COMMISSION DECISION

of 23 July 2012

amending Decisions 2006/861/EC, 2008/163/EC, 2008/164/EC, 2008/217/EC, 2008/231/EC, 2008/232/EC, 2008/284/EC, 2011/229/EU, 2011/274/EU, 2011/275/EU, 2011/291/EU and 2011/314/EU concerning technical specifications for interoperability

(2012/464/EU)

Figure I.5'

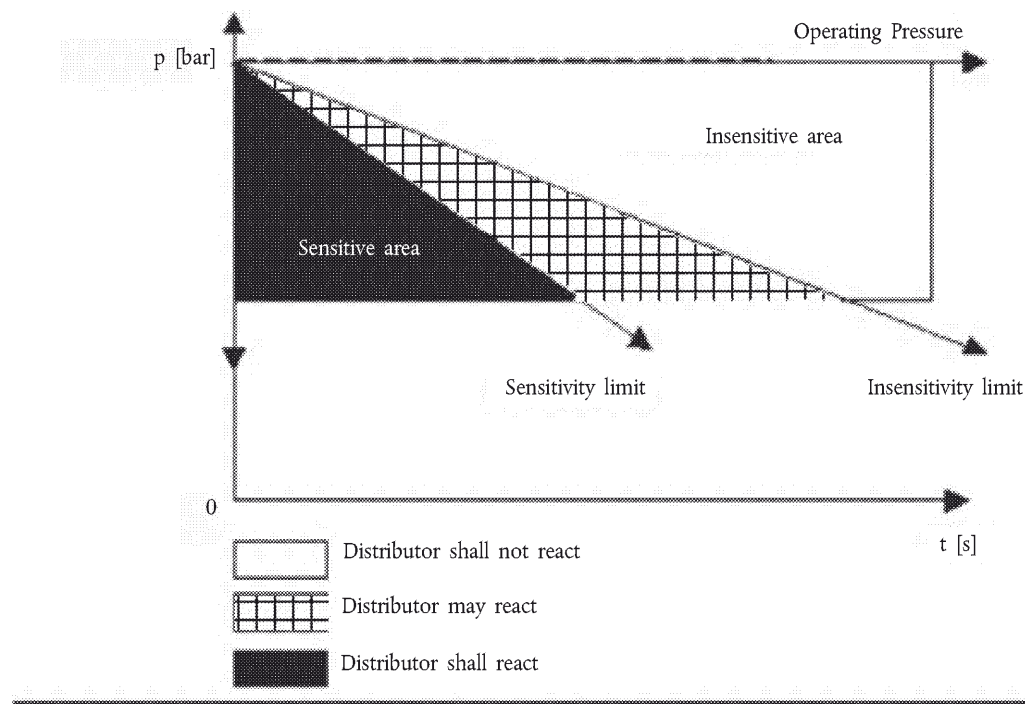
- (14) Annex D is deleted.
 (15) Annex H is deleted.
 (16) In Annex I, Figure I.5 is replaced by the following:

'Input Pressure (brake pipe pressure)

Figure 3'

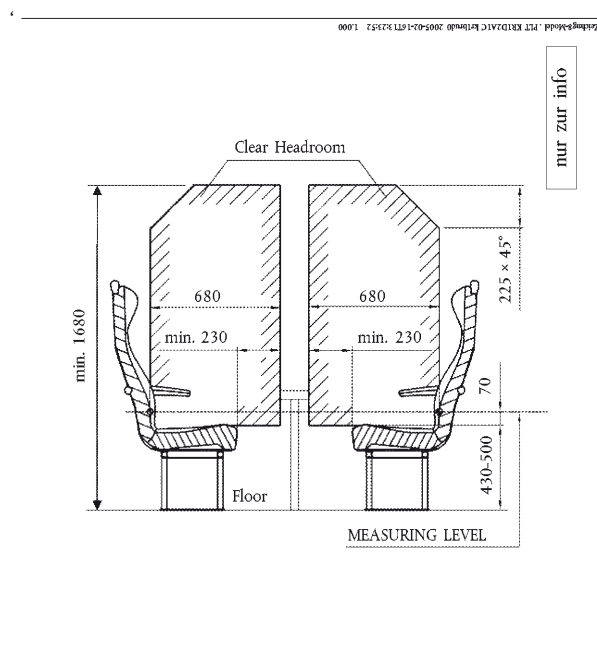
(2) In clause 4.2.2.2.1 ‘Priority seats. General’, figure 3 is replaced by the following:

Figure 1'

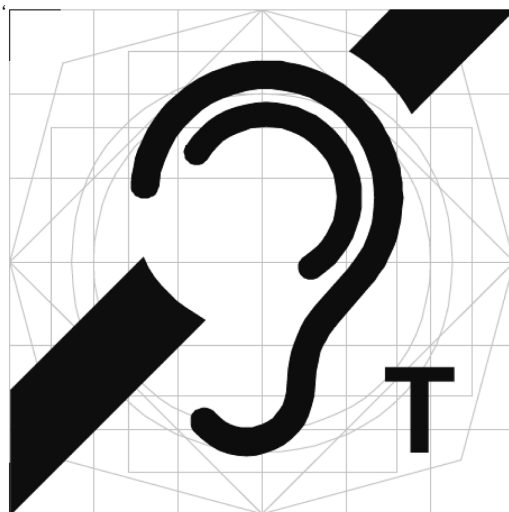
(4) In Annex N 'PRM Signage', figure 1 is replaced by the following:

‘Figure N1

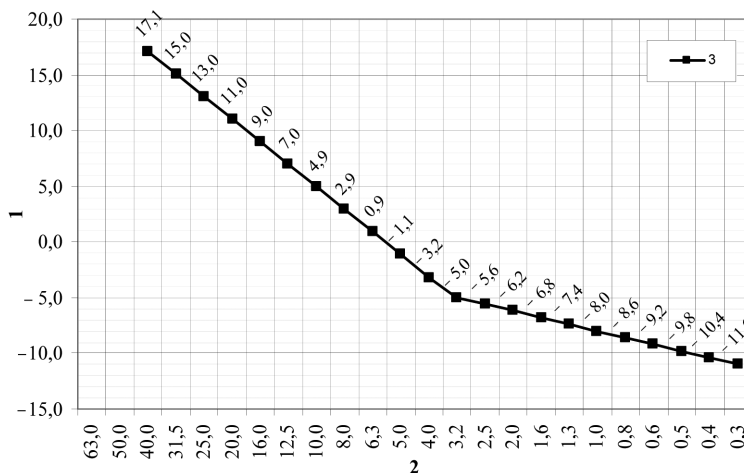
(33) In Annex N, figure N1 is replaced by the following:
